**CITY OF KELOWNA**  
**MEMORANDUM**

**Date:** November 16, 2020  
**File No.:** Z20-0096  
**To:** Suburban and Rural Planning (TC)  
**From:** Development Engineering Manager (JK)  
**Subject:** 1870 Treetop Rd

**WORKS AND SERVICES REQUIREMENTS**

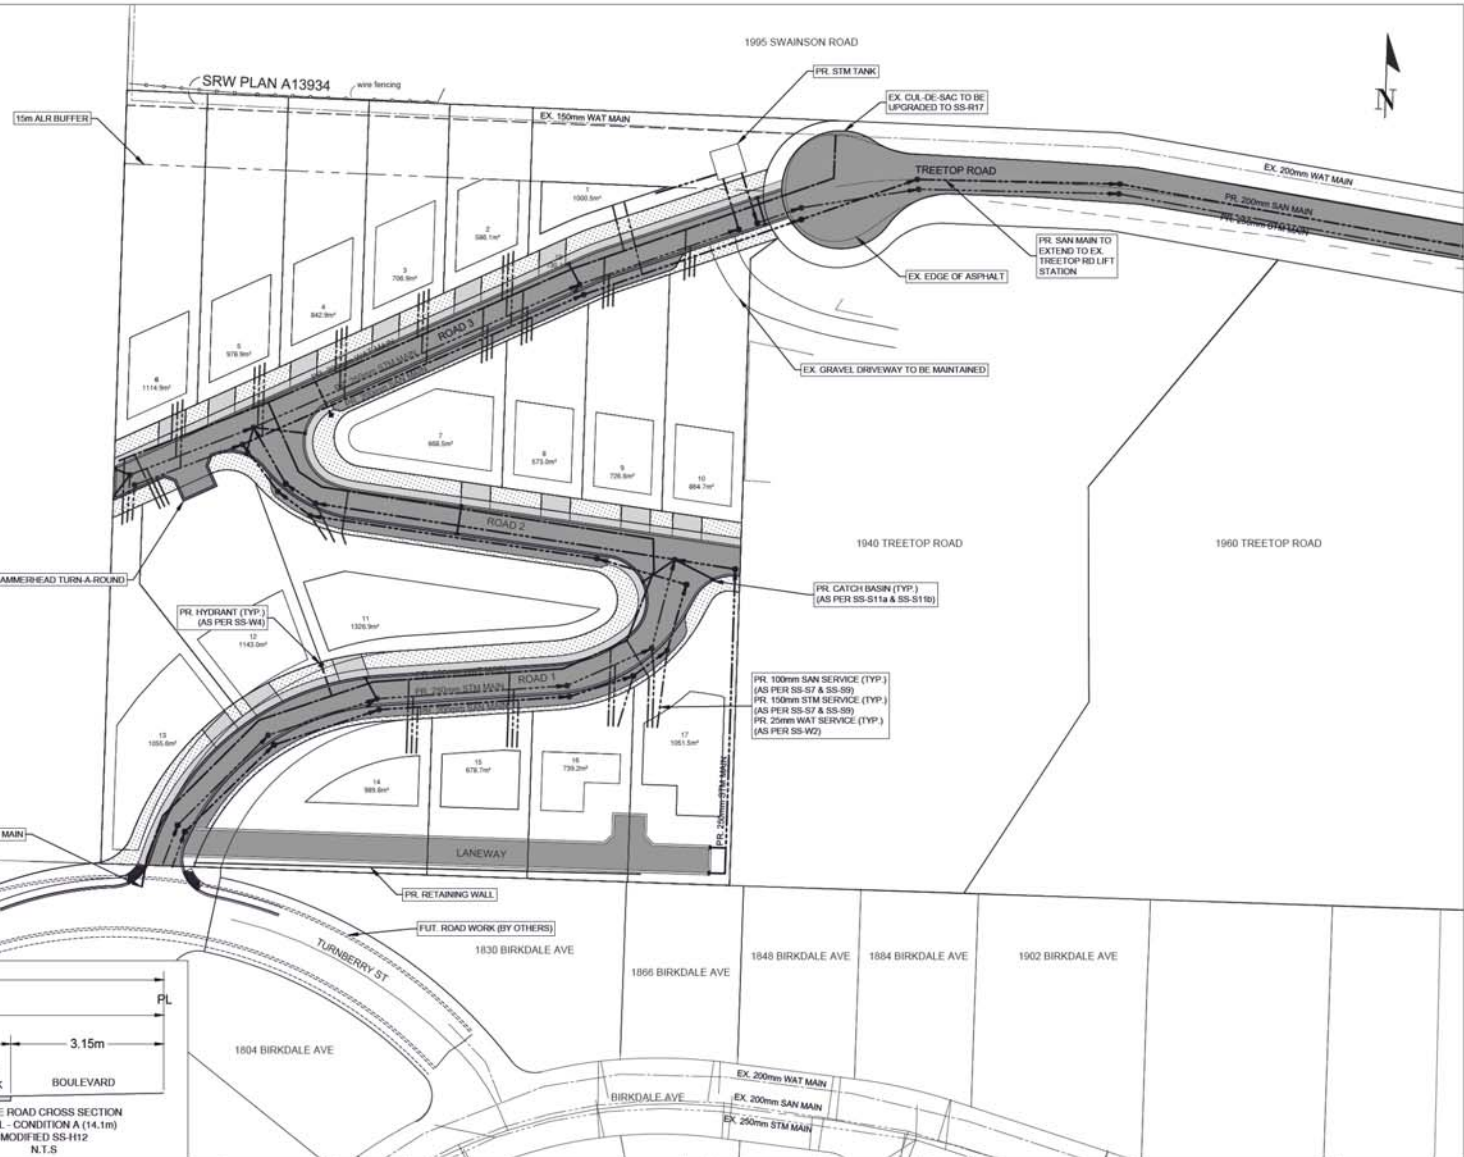
- a) Provide connection, through Turnberry St, to Birkdale Ave via existing driveway access easement at south west property corner.
- b) Turnberry St is included in the City of Kelowna's 2030 Official Community Plan (OCP) as a Minor Collector and its be designed as a modified SS-H6. Connecting development road should intersect Turnberry St at 90 degrees and must provide adequate site lines.

- c) A three-dimensional sight line and stopping distance analysis will be required to support the proposed Laneway along the south end of property. Ensure the sight and stopping distances are considered as per Bylaw 7900 Schedule 4 Section 4.1 General AND Section 7. Hillside Street Standards TABLE 2 Alignment Design Criteria.

- d) The proposed development includes access from Treetop Rd. As a result, upgrades will be required to the Treetop Rd cul-de-sac. Cross section to be used is modified SS-R17.

- j) Verify that physical driveway access will satisfy City requirements for all lots. For steeper lots (15% and greater), show driveways on the lot grading plan with grades or profiles.
- k) Roads 1, 2, and 3 are to be dedicated to the City of Kelowna with a 14.1m wide right of way (SS-H12).
- l) A 6.0 m corner rounding will be required on corner lots of intersecting public roads.
- m) Provide all necessary Statutory Rights-of-Way for any utility corridors required, including those on proposed or existing City Lands and private lands.
- n) Driveway access to 1865,1940, and 1960 Treetop Rd is to be maintained

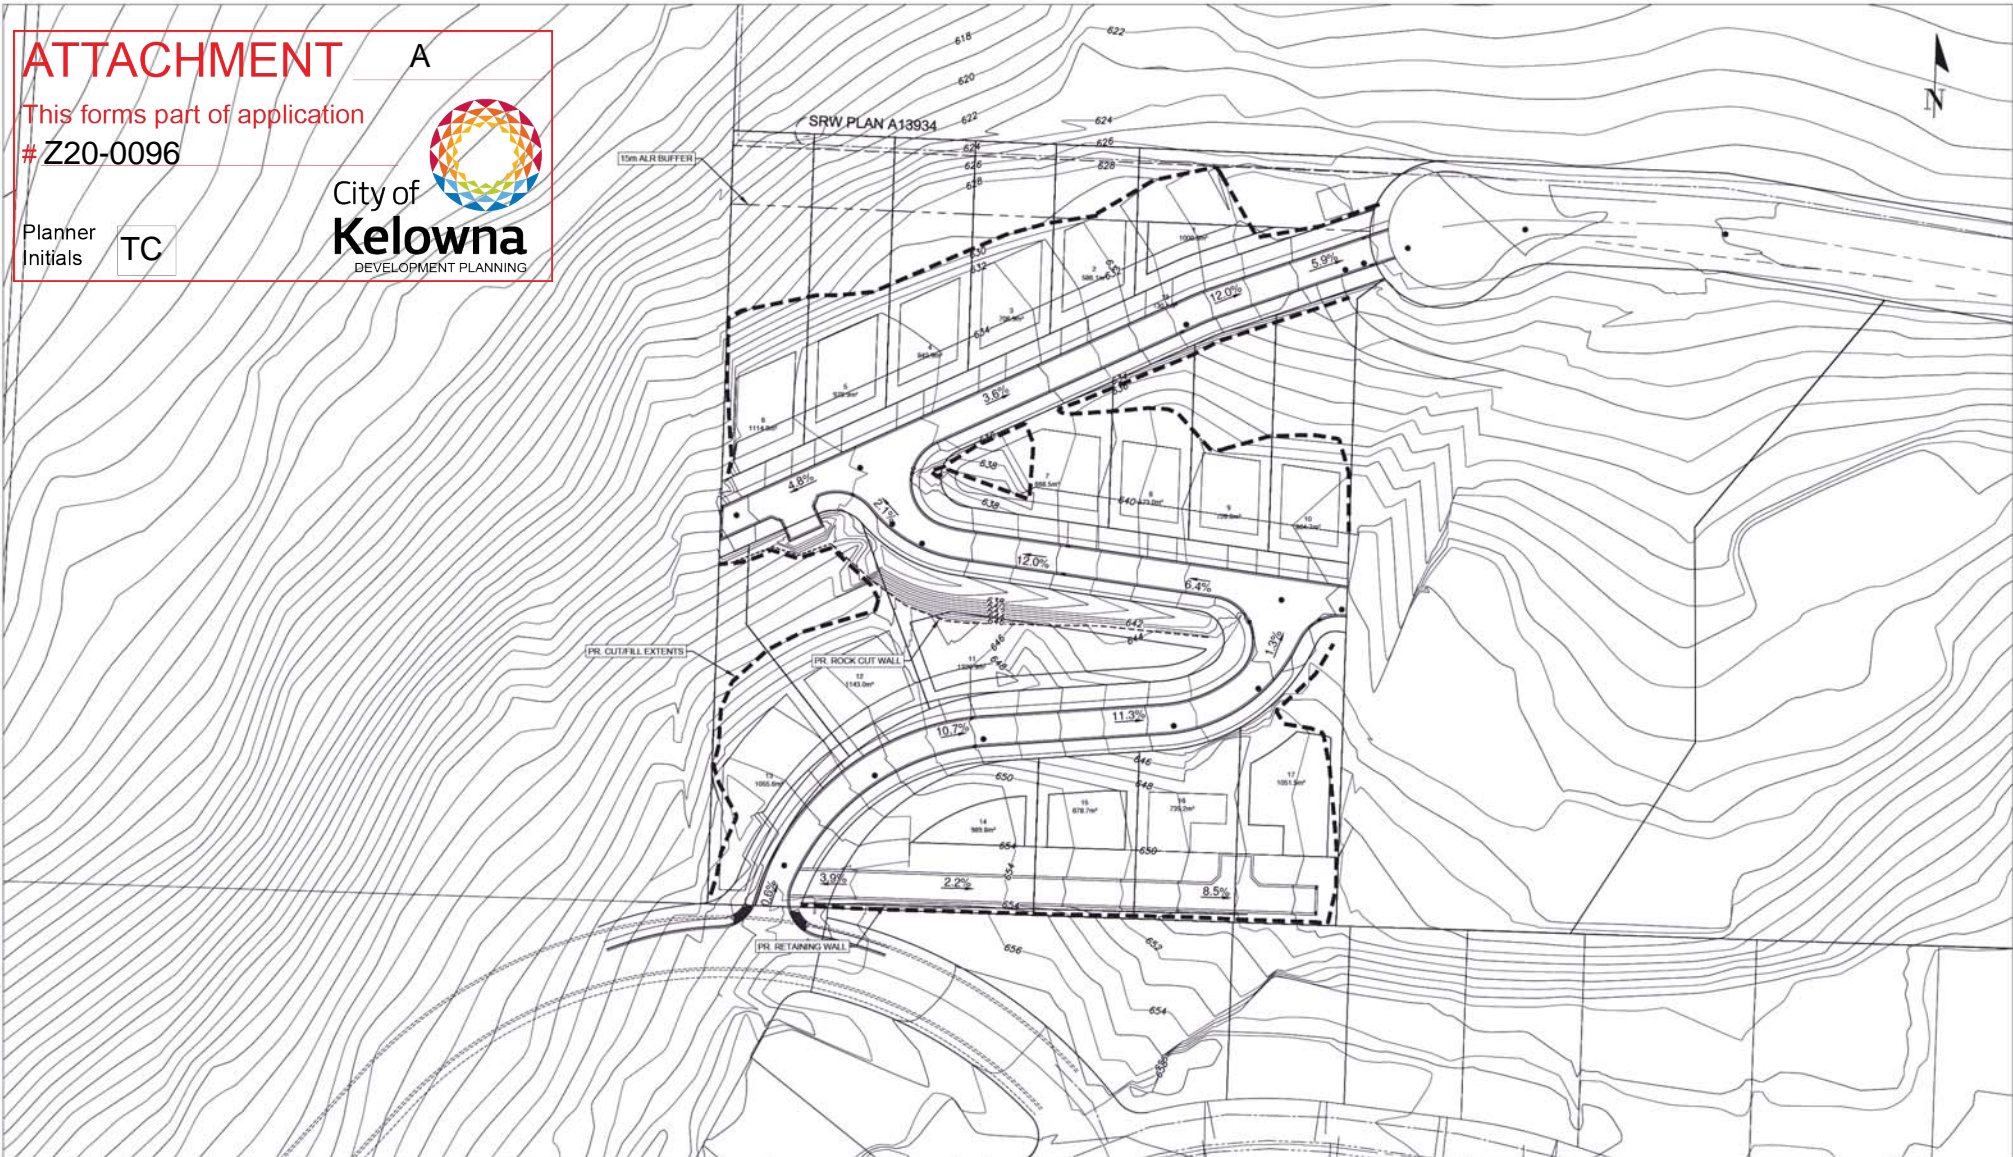
- b) Provide the following drawings:
  - i. A detailed Lot Grading Plan (indicate on the Lot Grading Plan any slopes that are steeper than 30% and areas that have greater than 1.0 m of fill);

- e) Show details of dedications, rights-of-way, setbacks and non-disturbance areas on the lot Grading Plan.

- g) Identify clearly on a contour map, or lot grading plan, all steep areas (>30 %). Provide cross sections for all steep areas at each property corner and at locations where there are significant changes in slope. Cross sections are to be perpendicular to the contour of the slope. Show the proposed property lines on the cross sections. Not all areas have a clear top of bank; and therefore, field reconnaissance by City staff and the applicant may be needed to verify a suitable location for property lines.
